## Staff Report to the Planning Commission

Application Number: **08-0120**

**Project Description:** Proposal to divide an existing 40,000 square foot parcel into four parcels and one remainder parcel for the construction of four single family dwellings each with an attached second unit. This project includes a sanitary sewer easement over the southwest adjacent parcel (APN 049-221-20), frontage improvements to the northwest adjacent parcel (APN 049-221-87), and an easement for partial street construction on the south adjacent parcel (APN 049-221-85). Requires a Minor Land Division, a Residential Development Permit, Preliminary Grading Approval, Soils Report Review, and a Roadside/Roadway Exception.

Street Improvements and Utility Plan

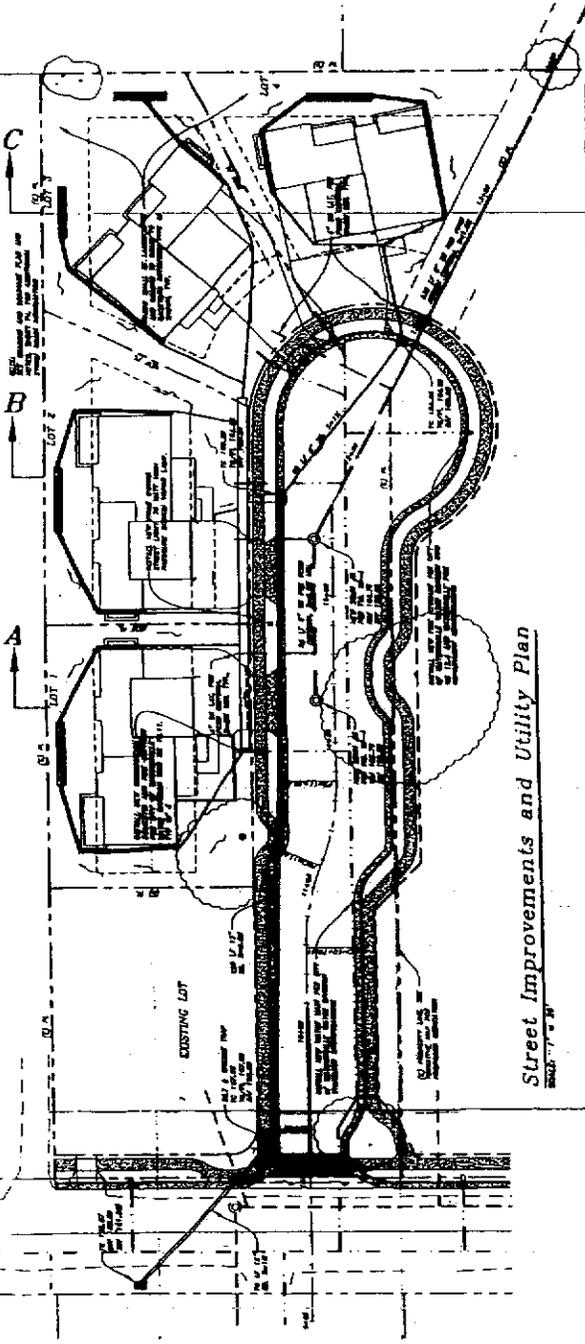
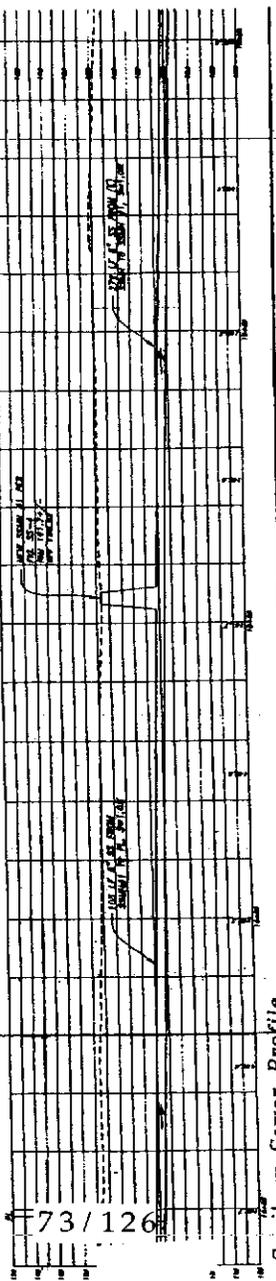
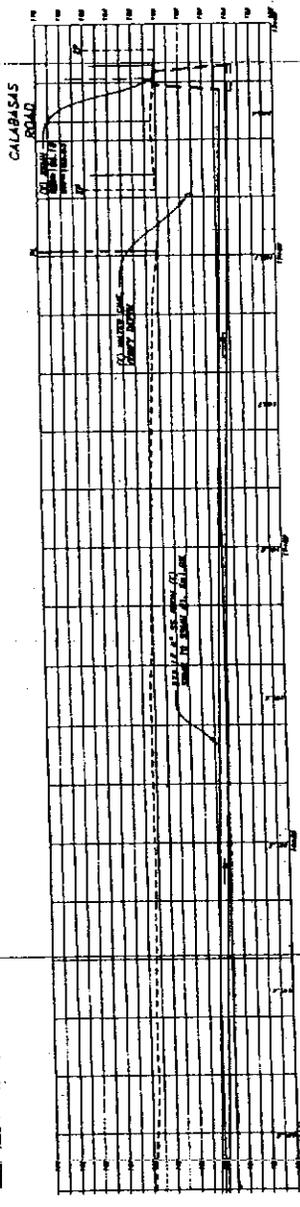
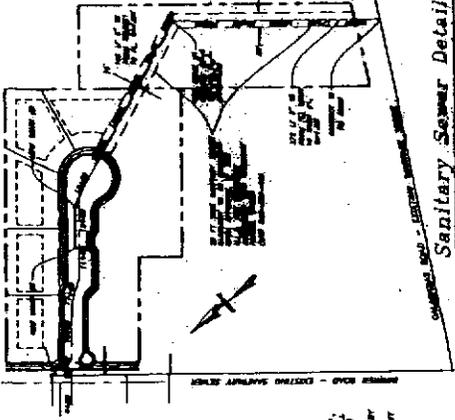
----- 1. The right-  
----- of-way and property lines are unclear on Sheet C2, C3, C5, and C7. If necessary each  
----- line should be specifically labeled to denote right-of-way, easements, etc.

----- 2. A -future-  
----- minor land division is shown on the Street Improvements and Utility Plan on Sheet  
----- C3. A separate dedicated sheet or view is required to show the potential development  
----- of the adjacent lot. No other sheet should show it. This also applies to the other  
----- -future- minor land division shown on the Sanitary Sewer Detail on Sheet C3

Use current version of Sanitation -General Notes.- Note 19, Sheet C3 needs revision.

Sewer lateral serving Lot 2 shall be connected to sewer main (not sewer manhole). Use current version of Sanitation -General Notes.- Note 19, Sheet C3 needs revision.

- c. The sewer lateral serving Lot 2 shall be connected to the sewer main (not sewer manhole). Use the current version of Sanitation General Notes, Note 19 and revise Sheet C3.
